MITSUBISHI SERVICE PUBLICATIONS TRANSMITTAL

SL 088/25-004A

Risk of Potential Adverse Effects on Radio/Radar Altimeters

Airworthiness Directives; Transport and Commuter Category Airplanes

Figure 1 to paragraph (g)(1)(i)— *Fundamental Effective Isotropic PSD at Outside Interface of Airplane Antenna*

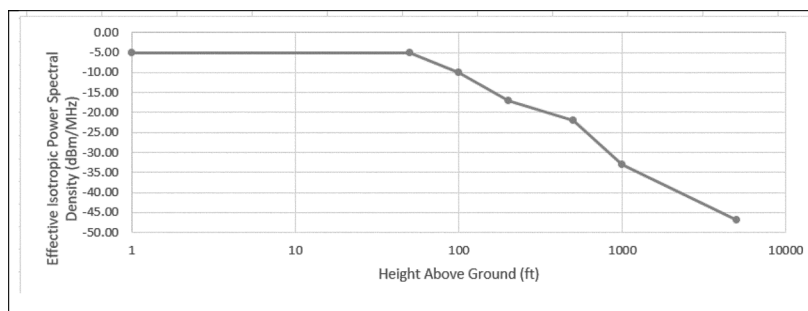
4. Request To Clarify Figure 1

Comment summary: Textron Aviation requested the FAA clarify at what reference point the PSD requirements apply. The commenter stated it assumed that they apply at the radio altimeter receive antenna input, such that antenna characteristics, coax loss, and filter characteristics would be included in the determination.

FAA response: The FAA agrees and has changed the title of figure 1 to paragraph (g)(1)(i) of this AD to reflect that the PSD requirements apply at

the antenna input to the radio altimeter, and that the figure applies to the outward facing side of the antenna.

Figure 2 to paragraph (g)(1)(ii)— *Spurious Effective Isotropic PSD at Outside Interface of Airplane Antenna*

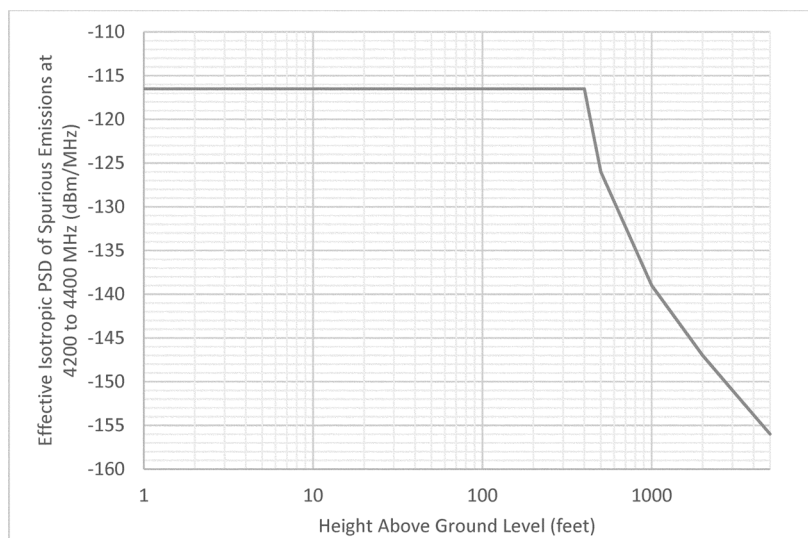
5. Request To Provide Additional Information on the Spurious Emission Tolerance

Comment summary: AIA requested that the FAA provide more information about the tolerances for determination of whether an airplane is radio altimeter tolerant. Several commenters requested that the FAA add a new figure indicating the spurious tolerance, similar to the figure with the PSD tolerance curve, and a specification of the altitude dependence for spurious tolerance.

FAA response: The FAA agrees and has replaced the proposed fixed emission level with a spurious PSD tolerance curve in figure 2 to paragraph (g)(1)(ii) of this AD. Subsequent figures have been redesignated accordingly.
